Product Change Notification / LIAL-09UEWG307

CCB 4395 Initial Notice: Qualification of MMT as an additional assembly site for selected Micrel products available in 16L VQFN (3x3x1.00mm) package.

CCB 4395
Pre and Post Change Summary
PCN # LIAL-09UEWG307

Lead frame comparison

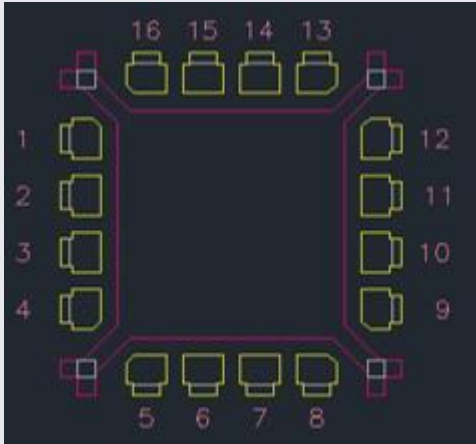
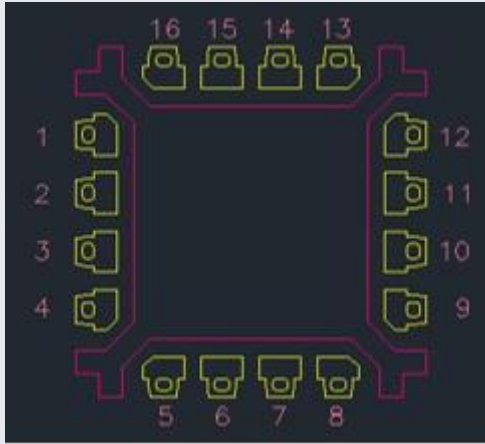
Pre Change: Assembled at UNIS assembly site using 8290 die attach, G770HCD molding compound material and without lead-lock lead frame

Post Change:Assembled at UNIS assembly site using 8290 die attach, G770HCD molding compound material and without lead-lock lead frame or assembled at MMT assembly site using 8600 die attach, G700LTD molding compound material and and with lead-lock lead frame.

Pre Change	Post Change	
Assembly Site	Unisem (M) Berhad Perak, Malaysia (UNIS)	Unisem (M) Berhad Perak, Malaysia (UNIS)	Microchip Technology Thailand (MMT)
Wire material	Au	Au	Au
Die attach material	8290	8290	8600
Molding compound material	G770HCD	G770HCD	G700LTD
Lead frame material	C194	C194	C194
Lead Frame Lead Lock	No	No	Yes
Moisture Sensitivity Level	MSL-2	MSL-2	MSL-1
